4521 19TH AVE NE

ADMINISTRATIVE DESIGN REVIEW 2

SDCI Project # 3035394-EG

1ST EDG COMMENTS

MASSING ANALYSIS

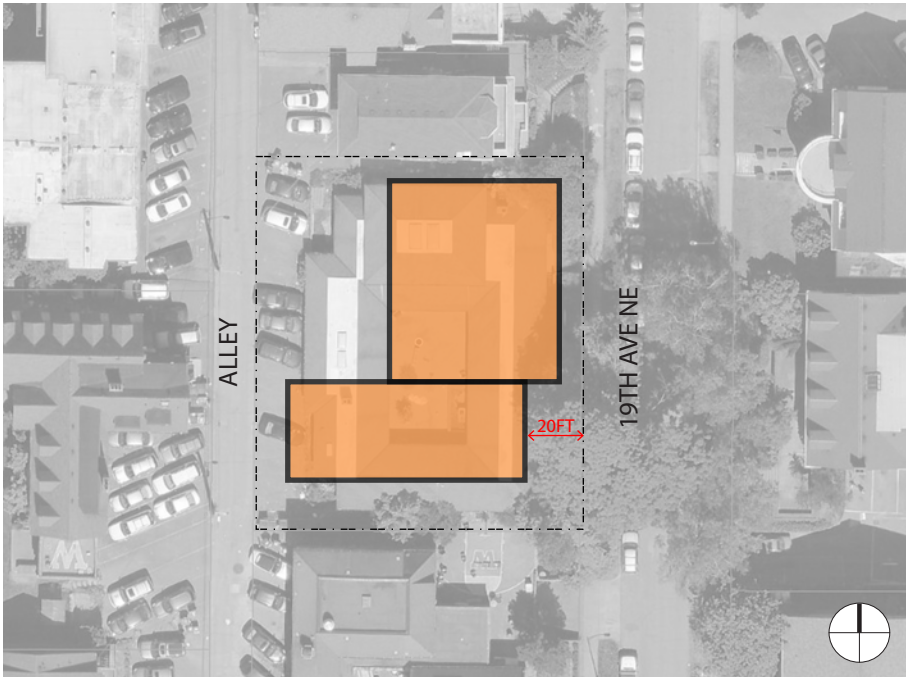
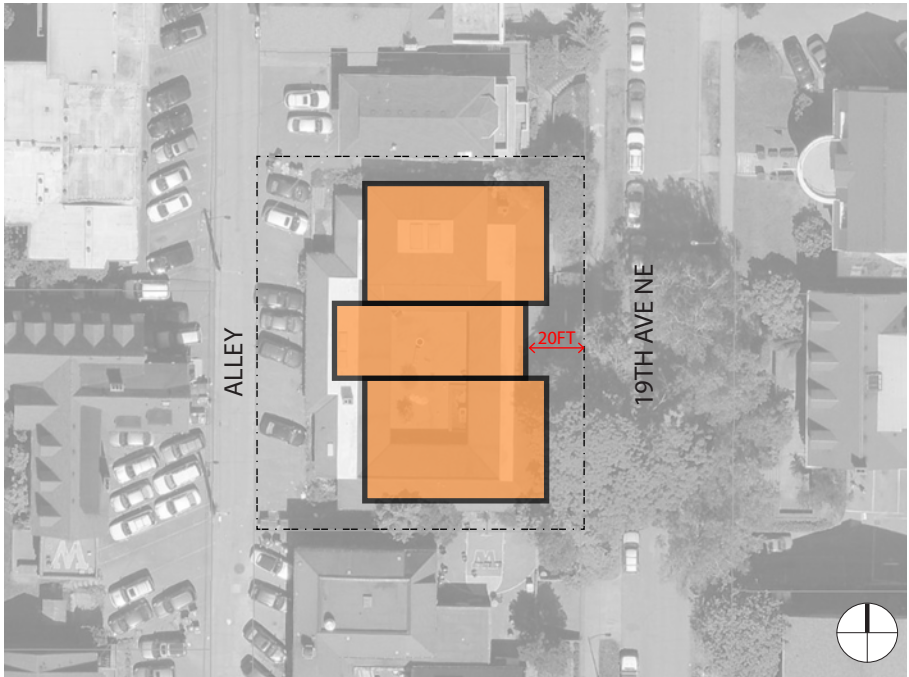
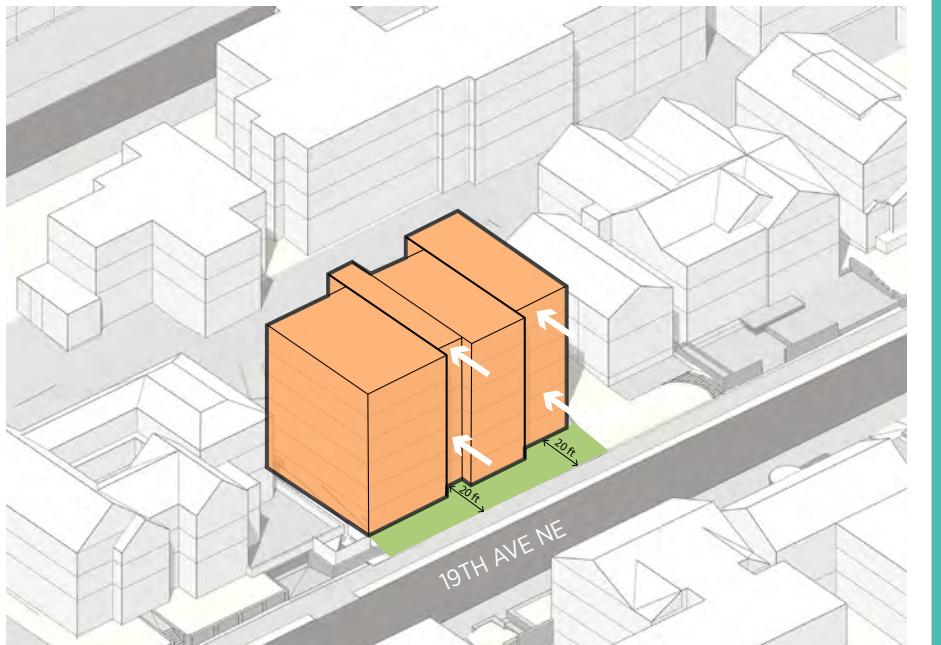
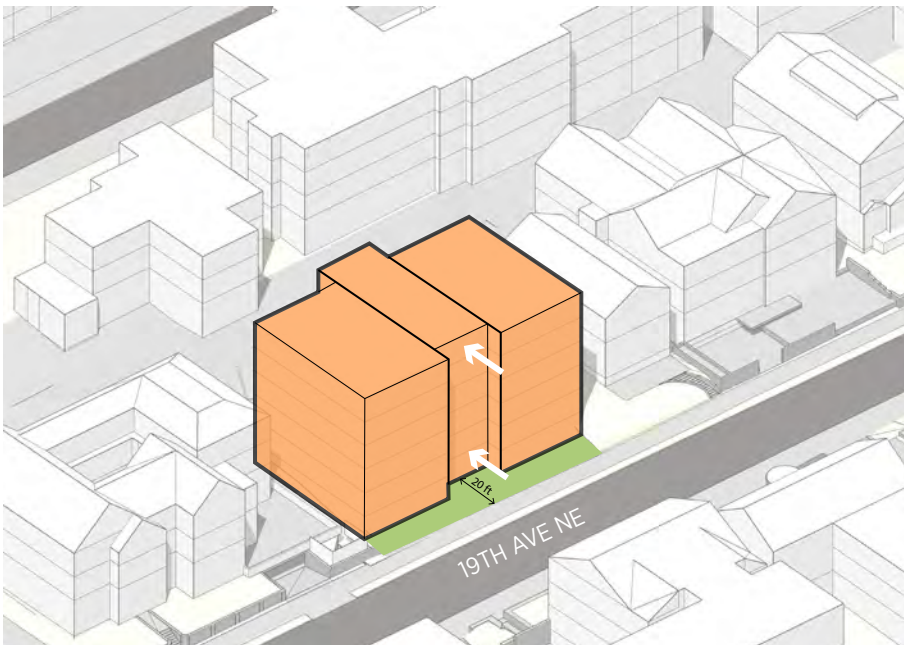
a. Staff recommends the examination of three new design and massing options that includes strategies that provide a better transition between the building mass/site design and the existing nearby development.

Three new options studies are provided, which explore with a series of masses that emphasize the relationship of mass design and open space location. Related to the different locations of the open space, building mass is broke into two, three, or four elements

STREETSCAPE & OPEN SPACE

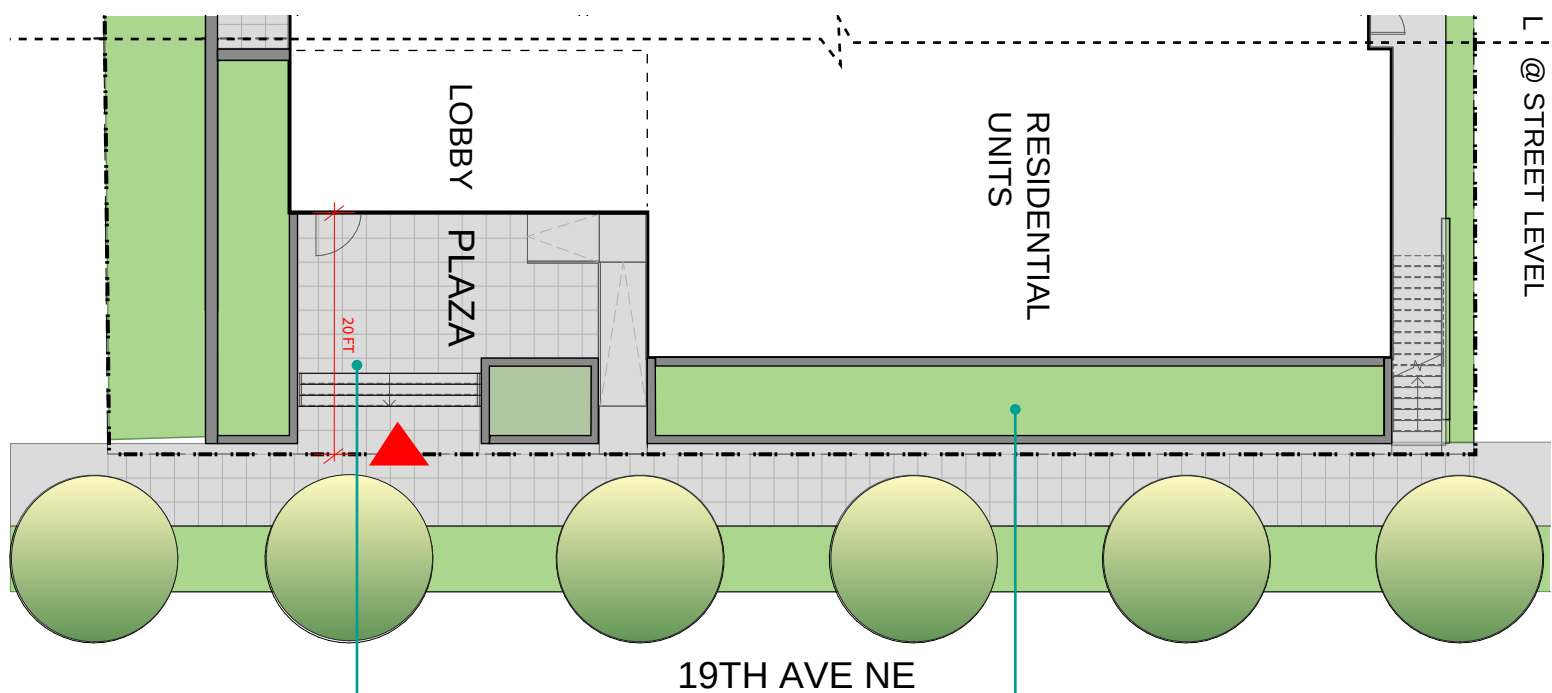
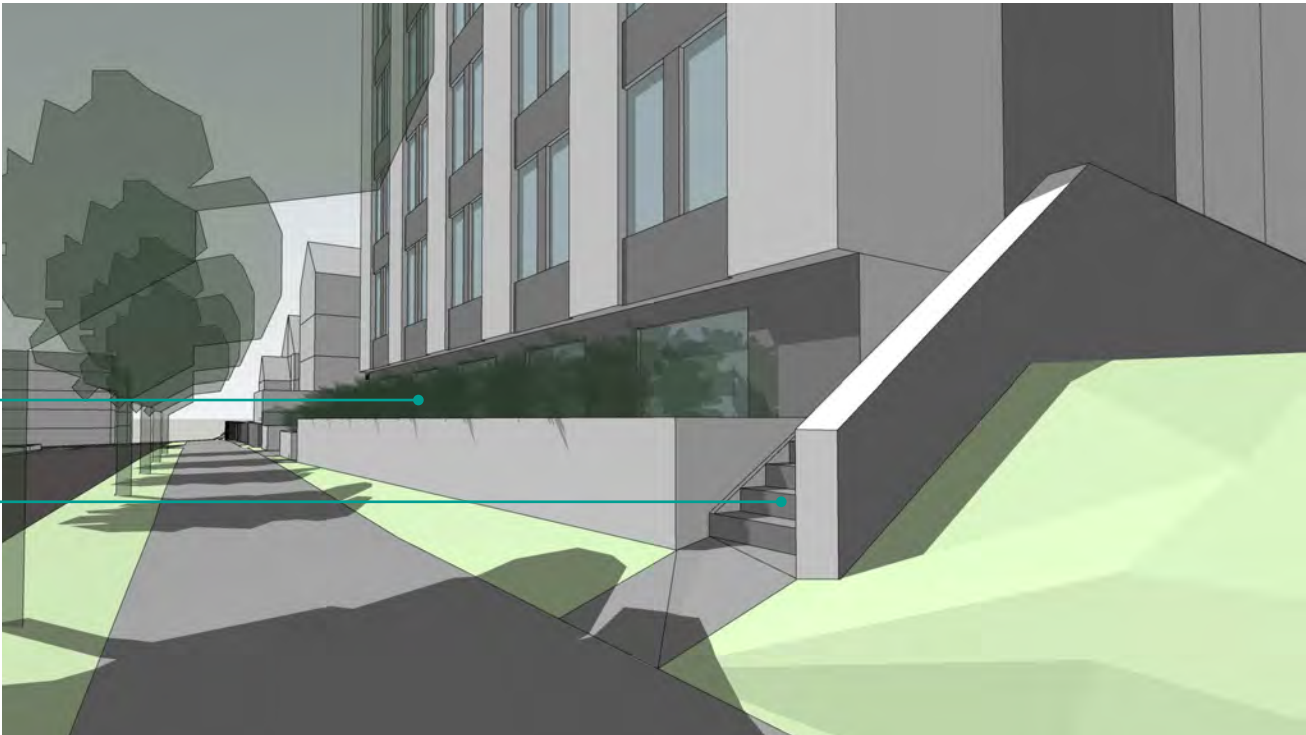
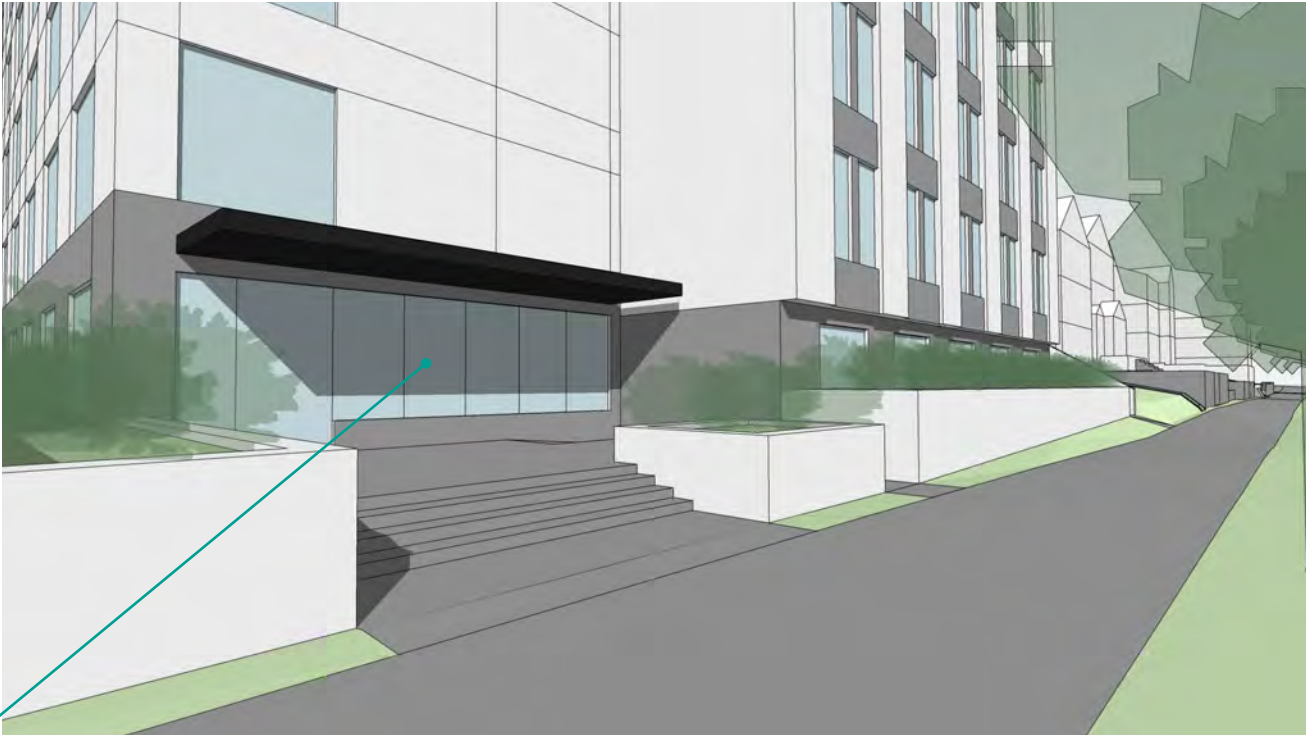
- a. Related to the guidance above for using open space to address context (1.b) examine the inclusion of open space raised in a high bank condition along the street frontage. Open space in this location can serve as an organizing element for the project design, mediate the grade transition from the site to the street frontage, and provide a gathering space for residents.
- b. Staff supports the design of patio spaces along the street frontage to serve the dual intent of establishing a visual connection to the street frontage while also allowing for a significant raised planter to address contextual topography.

- a. Three new options studies are provided, which explore with a series of masses that explore the relationship of mass design and open space location. Related to the different locations of the open space, building mass is broke into two, three, or four proportions.

An open space raised above the sidewalk in a high bank situation makes no sense for this type of project: 1. There is an extensive roof garden, 2. This is not a fraternal orgaization where people live, know and play with each other, 3. It's facing East, 4. It's inclusion would negatively impact the adjacent units
